**ON-SITE SEWAGE DISPOSAL SYSTEM  
HOWARD COUNTY HEALTH DEPARTMENT  
BUREAU OF ENVIRONMENTAL HEALTH**

SUBDIVISION: Twelve Hills LOT NUMBER: 52

ADDRESS: 13060 Twelve Hills Road PROPERTY OWNER: Glenn Bowman

RE: Site Inspection for Existing SDA Location  
Twelve Hills Two-Lot Subdivision  
Tax Map: 28 Lot: 52

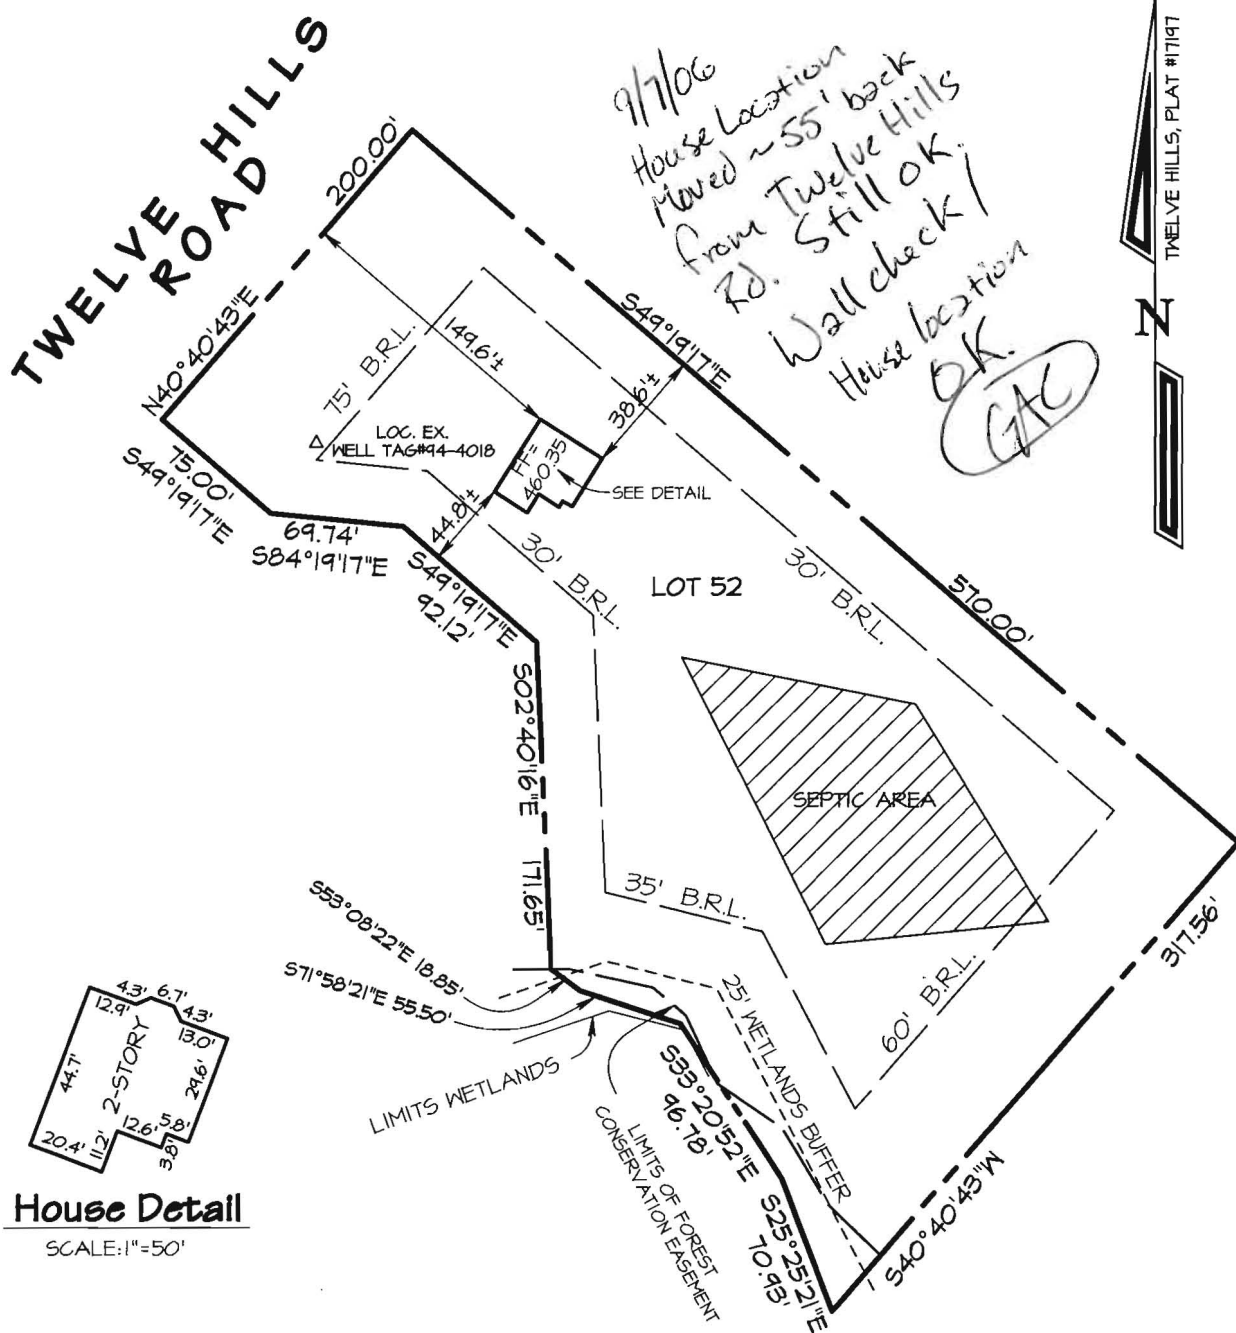
**RECOMMEND 1250 GAL ST, 1000 GAL IS THE MINIMUM**

TRENCHES:	Use existing trenches, 3 trenches at 88 feet each, trench width= 2' wide, depth= 7.5', inlet at 3.5', effective area at 4', total trench length 265.5 feet.
LOCATION:	Install septic tank as shown.
NOTES:	Basement not gravity service. Using existing trenches, only need to install septic tank.

INSTALLATION 10/19/06 Need house connection (BB) 2/2/07  
installed. Verified on phone. via house owner. (KW)  
House connection

## FILE INQUIRY NOTES

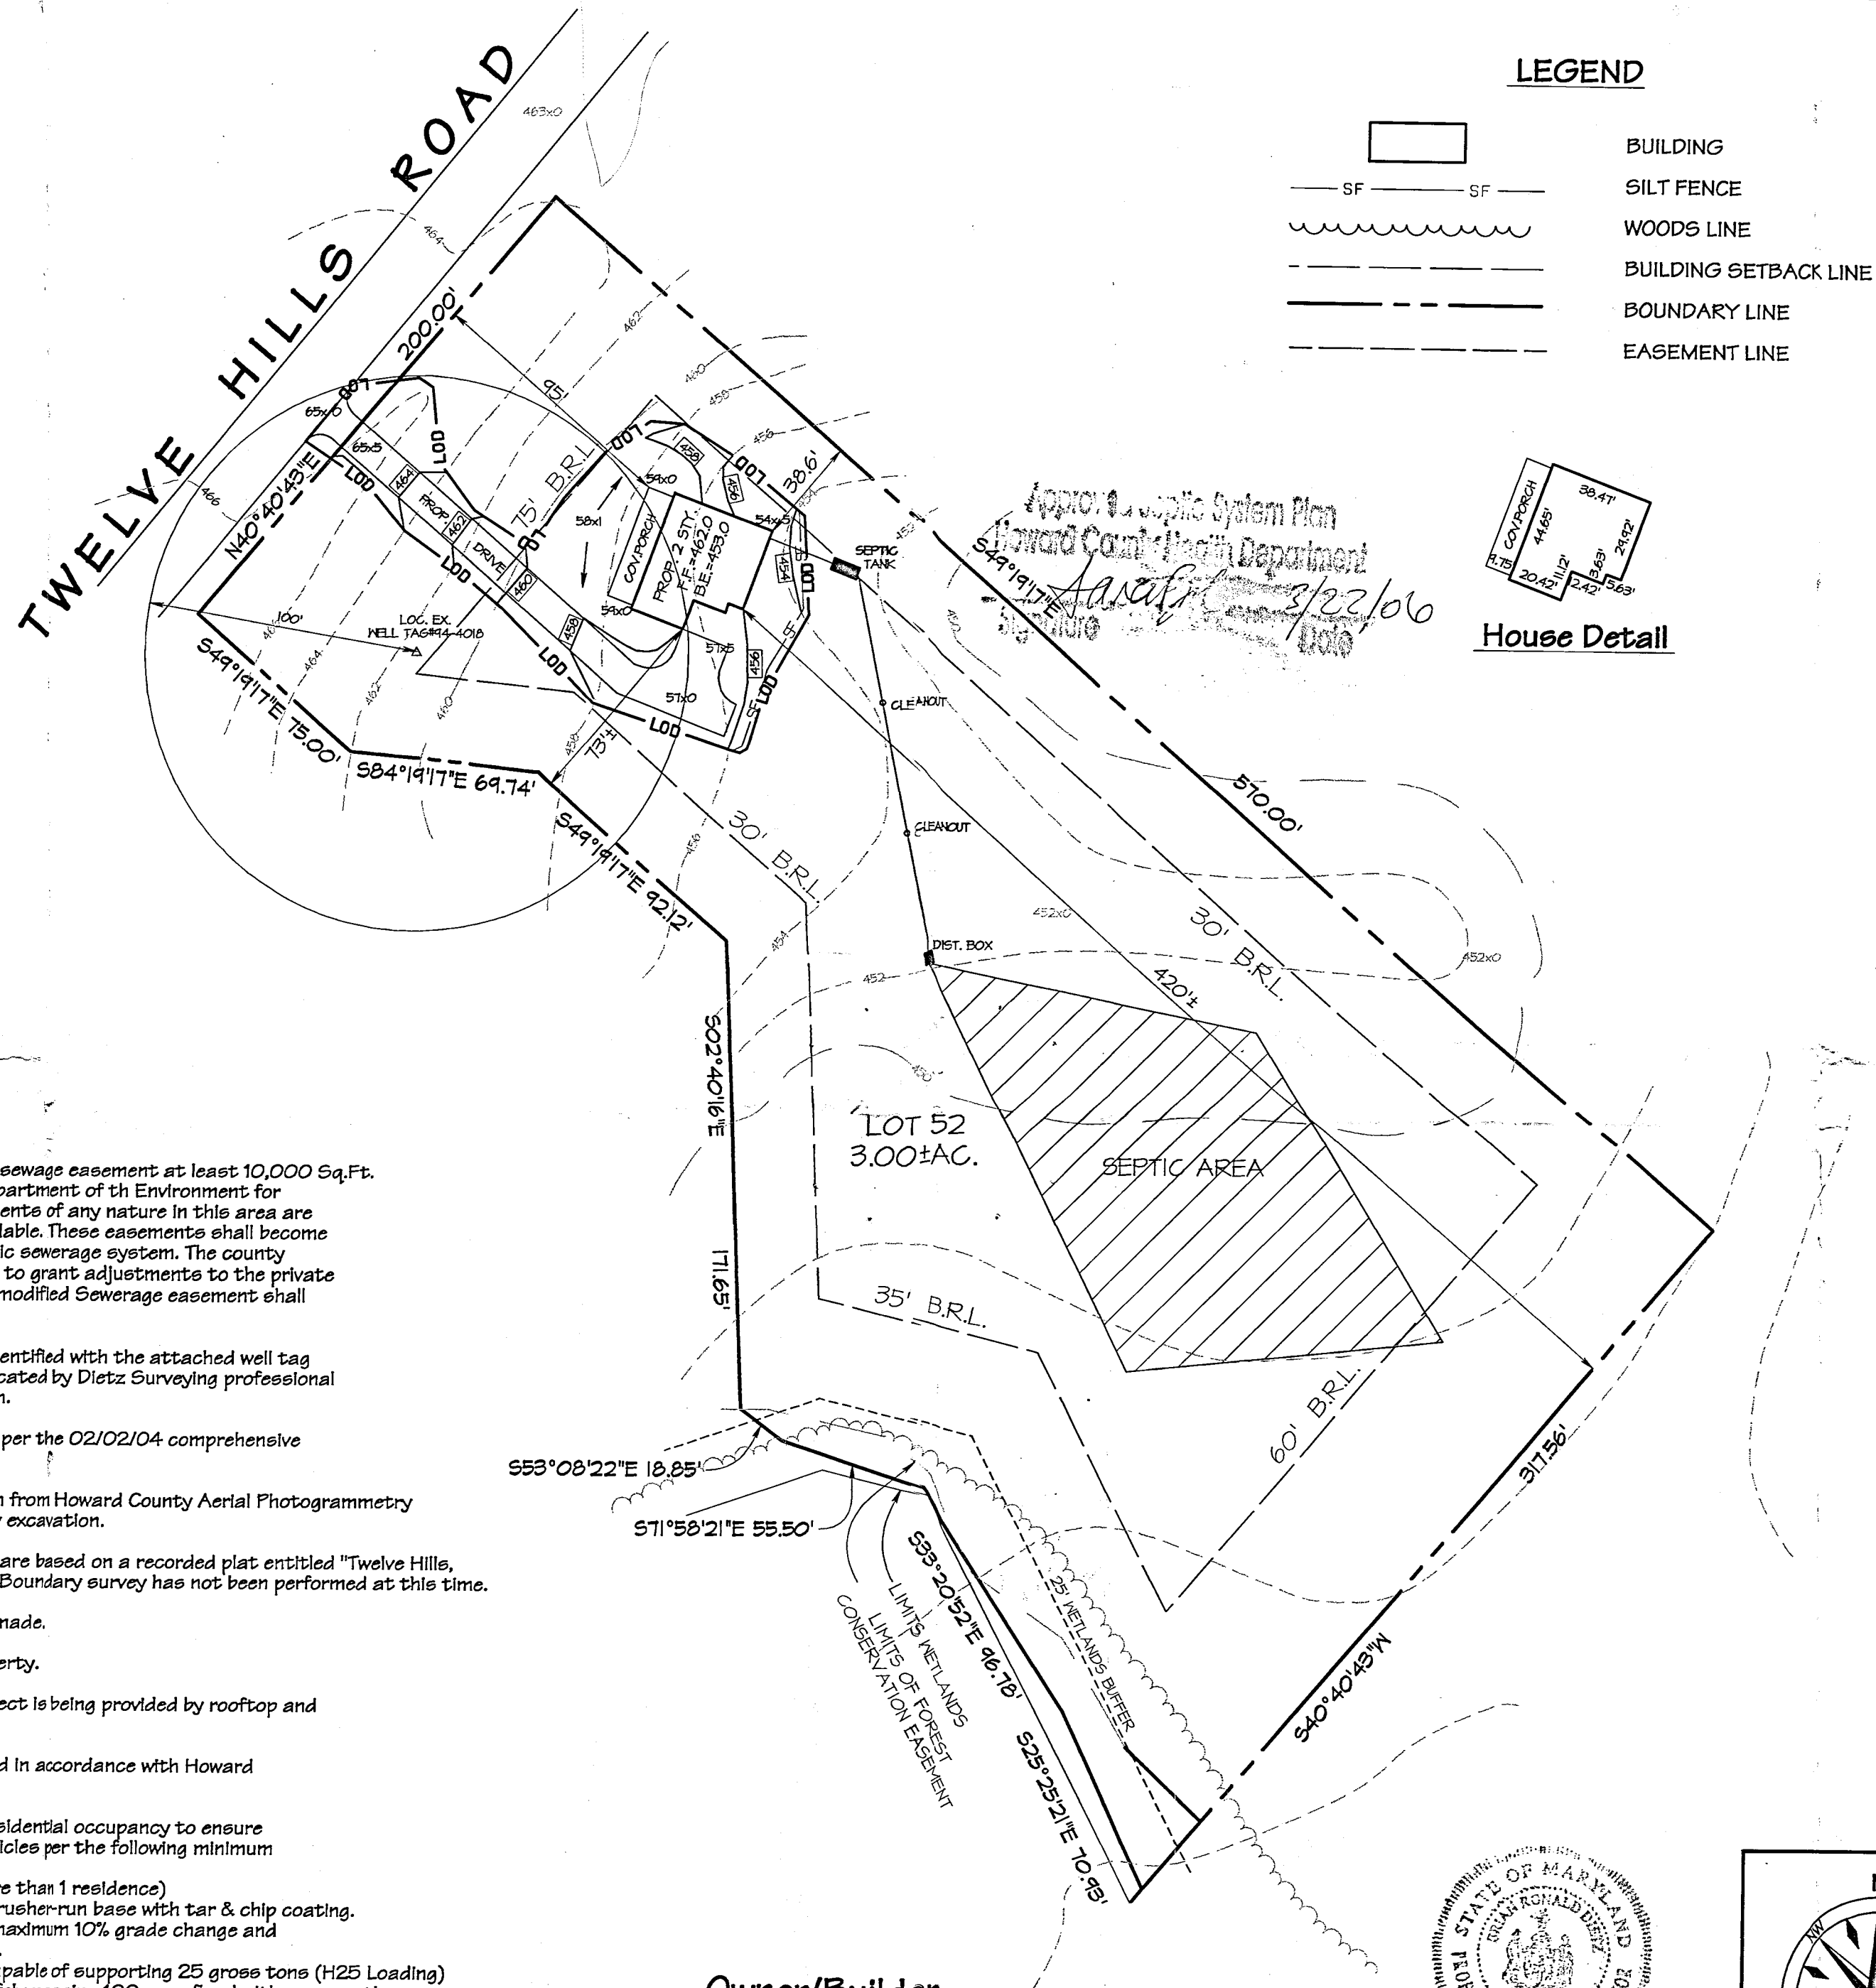
DATE	RESULTS OF REVIEW FOR FILE
	KC.
	Bruce Jackson ( <sup>prospective buyer</sup> 646-623-1707) has
	questions about the over sized easement
	on Lot 52. Wants to move it.
	Isma <del>to</del> (owner) is also inquiring about
	this file. Could you fill me in
	on what's out here, or call
	Bruce Jackson back.
	He - either wants to
	① Shrink the 10,000.
	② Move it up 10, feet.
	③ Move it any where else.
	9/30/05 (Poy)
